**GOVERNMENT OF INDIA  
MINISTRY OF RAILWAYS  
RESEARCH DESIGNS AND STANDARDS ORGANISATION  
Manak Nagar Lucknow - 226 011**

**Modification sheet No. RDSO/WAM4/201**

Modification to provide HRC fuses for protection of RPS in AC Electric Locomotives.

REF. NO.	PART NO.	DESCRIPTION	DETAIL DRG. NO.	NO/EMU	MATL.	SPEC
REF. :			SCALE: NTS	APPD. BY	(FOR DG) <i>Paul</i>	
PROPOSED LOCATION OF HRC FUSES -100 Amps. FOR WAM-4 (2S-3P)				FIRST ISSUED	---	
				SUPERSEDES	-----	
RDSO. ELECT. DTE				SUPERSEDED BY	----- SKEL - 4458

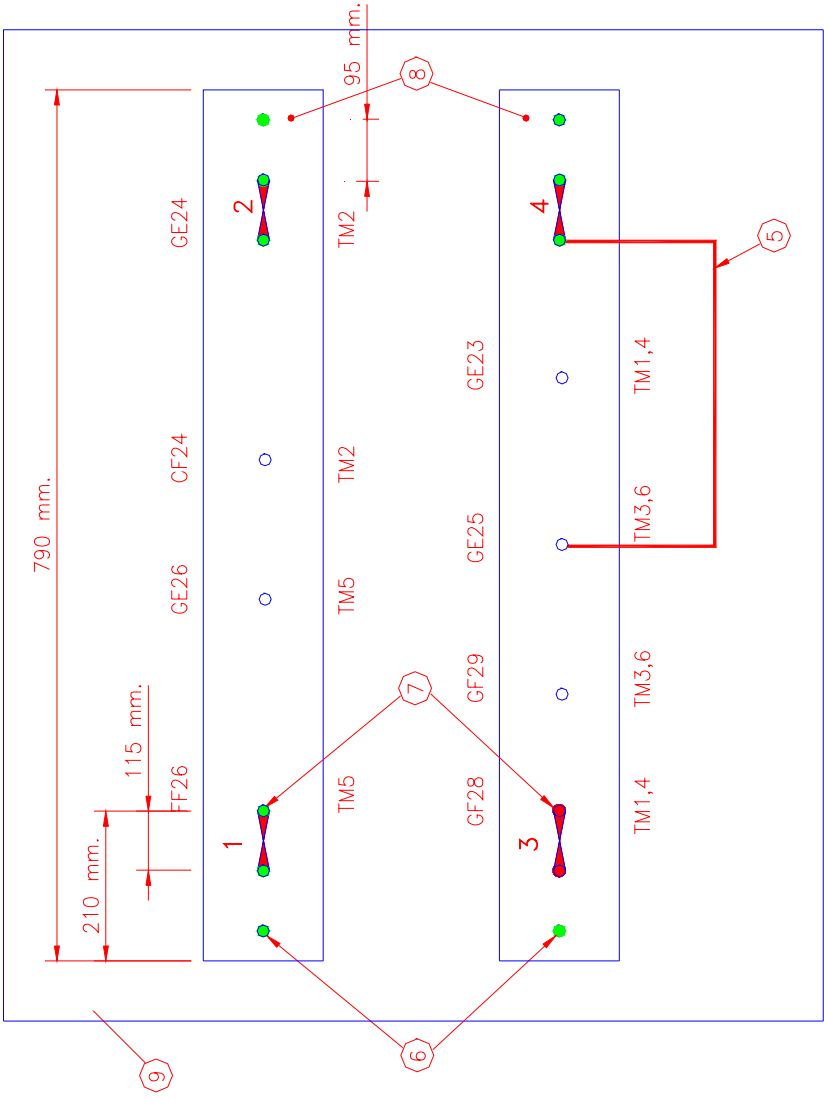
- i) The schematic of concerned power circuit indicating **HRC** fuse arrangement in WAM4 (2s-3p) and other 6P locos have been shown in RDSO's Drg.No.SKEL-4457 and SKEL-4459 enclosed herewith.
- ii) The modified arrangement of RPS terminal box with provision of **HRC** fuses as per above schematic of power circuit for WAM4 (6p), WAP1 (6P), WAM4, WAG5 and WAG7 class of Electric locomotives have been shown in RD SO's Drg. No.SKEL-4458 and SKEL-4460 enclosed herewith.

1. HRC FUSE FOR TM5-100 Amps.
2. HRC FUSE FOR TM2
3. HRC FUSE FOR TM4,1
4. HRC FUSE FOR TM3,6
5. NEW SHORTING LINK  
( Cu. FLATE OF SIZE-3mmX50mm)
6. FIXING BOLTS
7. PROPOSED BOLTS AND NUTS  
FOR HRC FUSE.
8. 30mm. THICK HYLAM  
TERMINAL BOARD.
9. RPS PANEL.
